**AGENDA
OVERLAY DISTRICT BOARD
MARCH 3, 2020**

TO: Overlay District Board
FROM: June Sin, Planner
DATE: March 2, 2020
SUBJECT: **Consideration of Two Alternative Standards to the IH-35E Corridor Overlay District Regarding Sidewalks and the Amenity Zone Landscaping Associated with Proposed 151 Coffee on a 0.53-Acre Lot, Legally Described as Valley Square Addition, Block A, Lot 7; Zoned General Business (GB) District, as Requested by Clay Christ, of Clay Moore Engineering, on Behalf of LRIC Lewisville, LP, the Property Owner (Case No. ODB-2020-02-01).**

Re: 151 Coffee Alternative Compliance

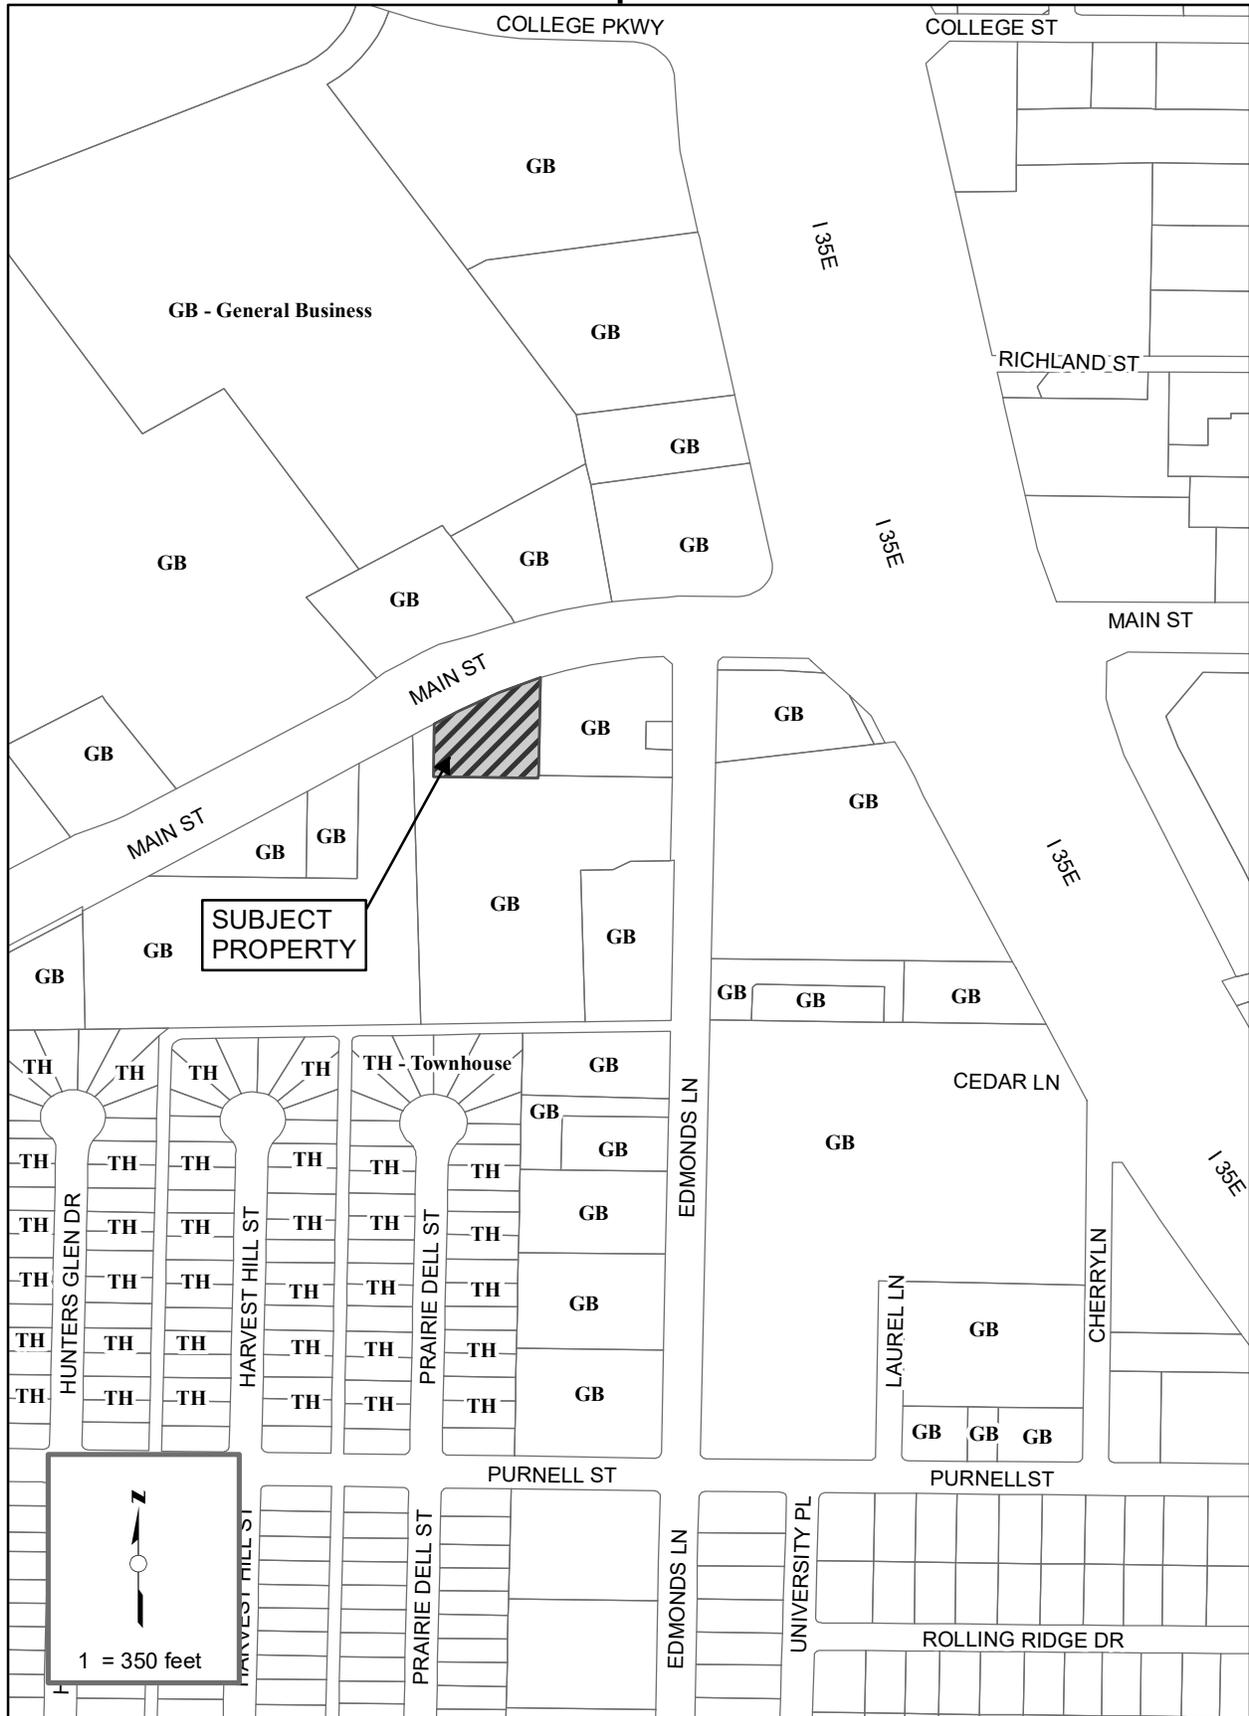
- a) Section 17.5-4 (d)(1)d requires canopy trees to be planted within the required Amenity Zone. An Alternative Standard is requested to allow canopy trees to be planted on the private property side within a five-foot wide landscape area between Sidewalk and Parking Lot due to the TxDOT ROW. The Overlay Board may make a recommendation to the City Council on this request.
- b) Section 17.5-4 (e)(4) & (5), Appendix F requires a 5-foot sidewalk along Main Street. An Alternative Standard is requested to allow existing 4-foot sidewalk to remain, which is a 20% reduction from the requirement. To preserve the existing robust hedge row, staff is in support of keeping the 4-foot sidewalk in this case. Overlay Board may approve this request.

That the Overlay Board commission recommend approval of Alternative Standard a) and approve Alternative Standard b) with the condition the existing shrub row is maintained.

ALTERNATIVE
COMPLIANCE SITE PLAN

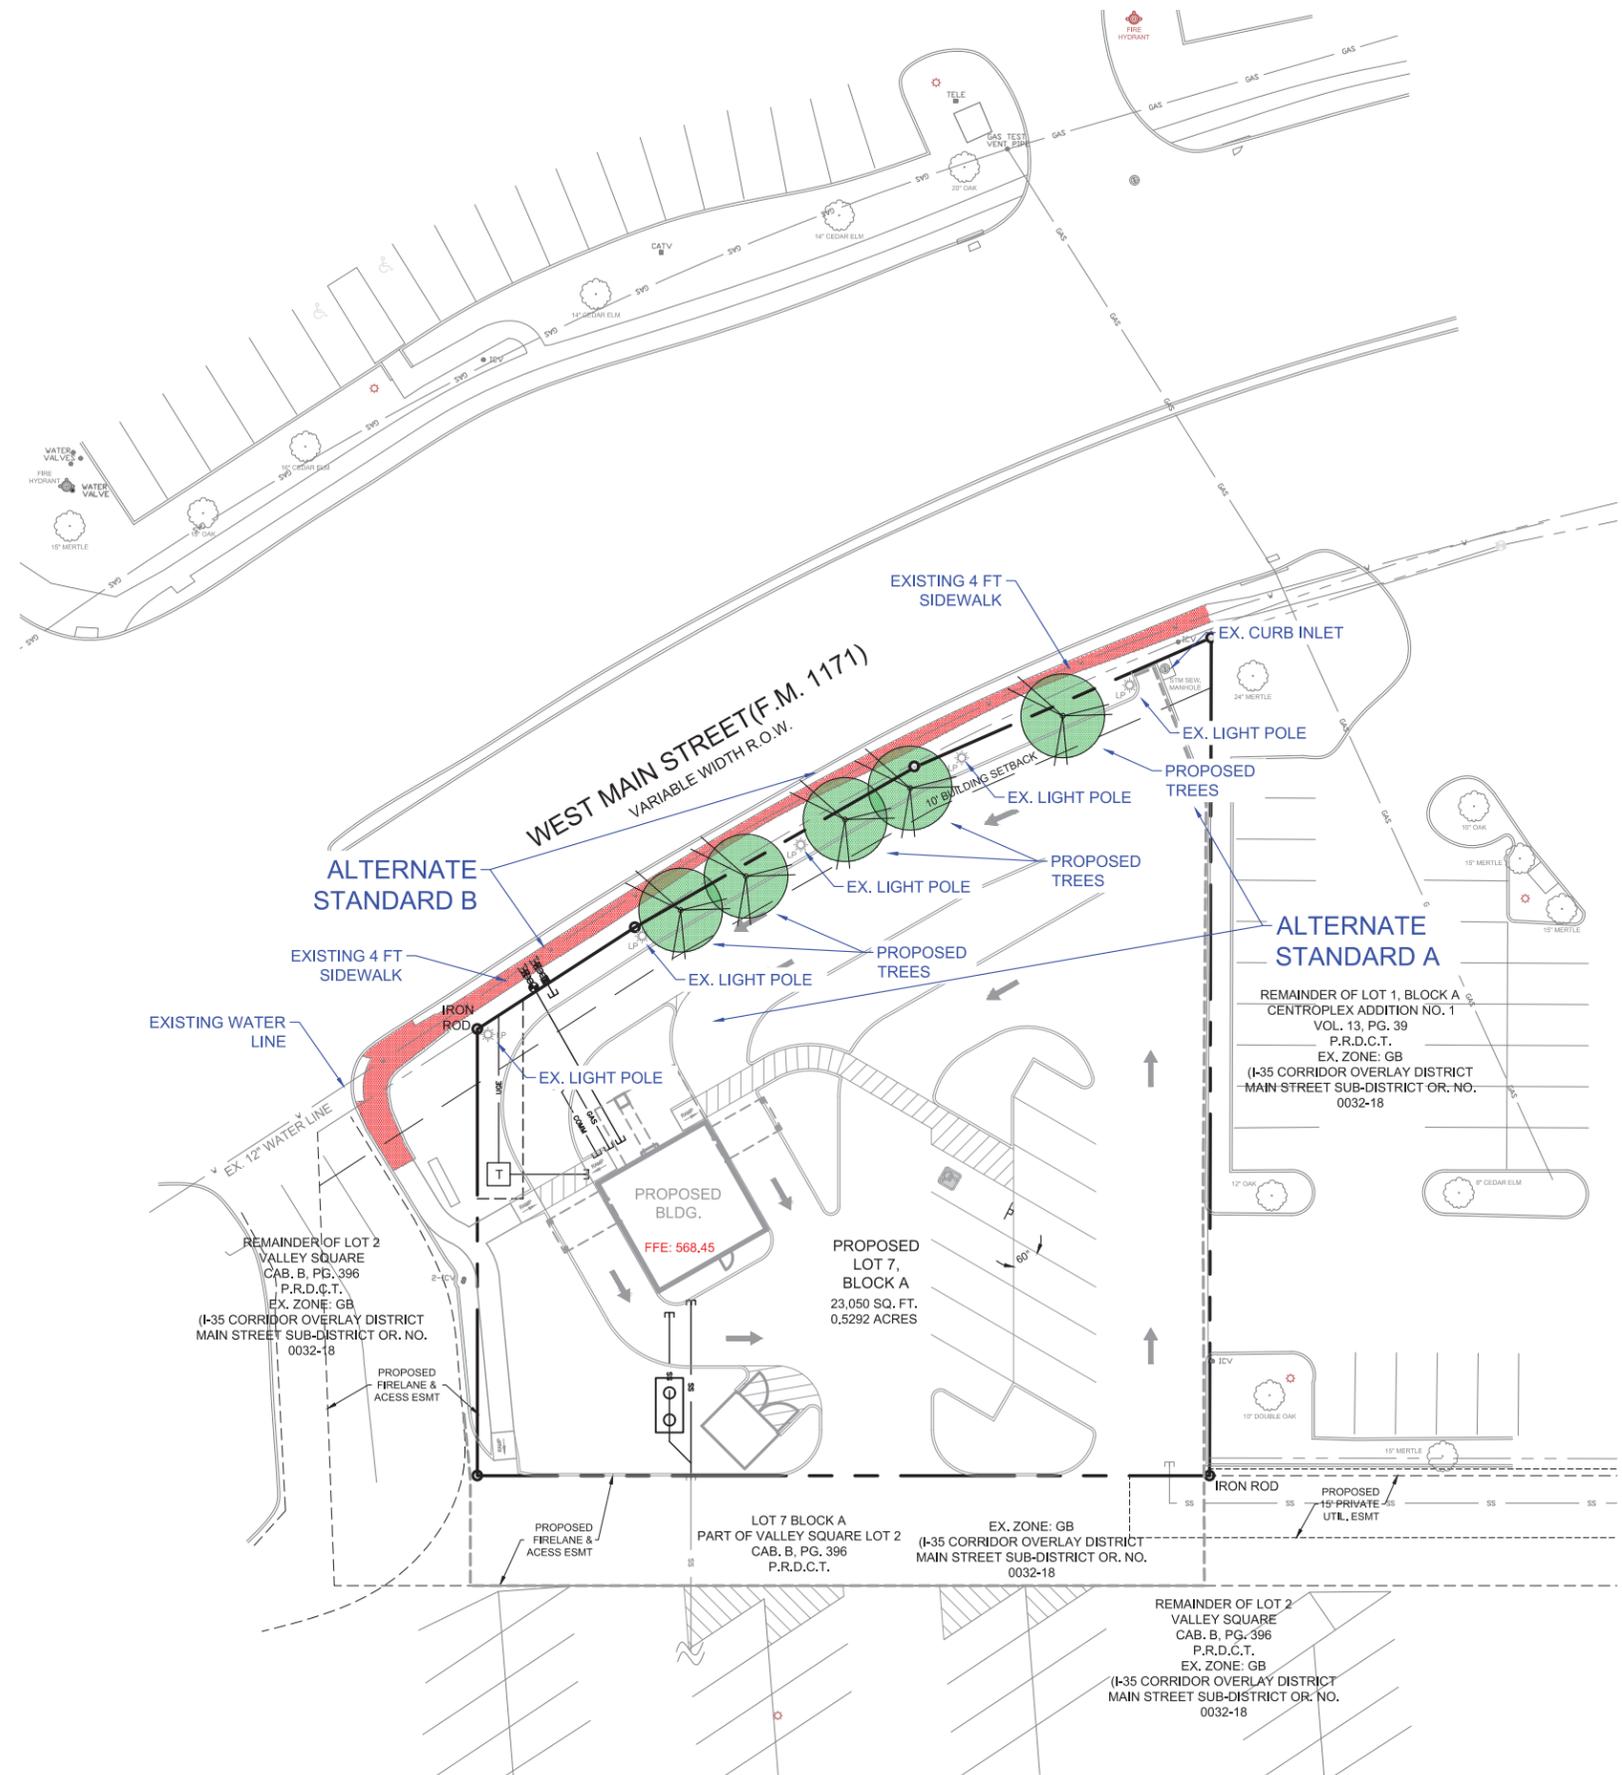
- ALTERNATE STANDARD A**
 SECTION 17.5-4 (D)(1)D REQUIRES CANOPY TREES TO BE PLANTED WITHIN THE REQUIRED AMENITY ZONE. DUE TO THE AMENITY ZONE BEING LOCATED WITHIN THE TXDOT RIGHT-OF-WAY, AN ALTERNATIVE STANDARD IS REQUESTED TO ALLOW CANOPY TREES TO BE PLANTED ON THE PRIVATE PROPERTY SIDE WITHIN A FIVE-FOOT WIDE LANDSCAPE AREA BETWEEN SIDEWALK AND PARKING LOT.

- ALTERNATE STANDARD B**
 SECTION 17.5-4. (E)(4) & (5) REQUIRES A 5' SIDEWALK ALONG MAIN STREET. THERE IS AN EXISTING SIDEWALK IN PLACE THAT WE WOULD REQUEST BE ACCEPTED FOR THE SIDEWALK AND AMENITY REQUIREMENT. IT IS REQUESTED TO ALLOW THE SIDEWALK WIDTH TO BE REDUCED FROM 5' TO 4' WHICH IS A 20% REDUCTION IN THE WIDTH OF THE SIDEWALK.
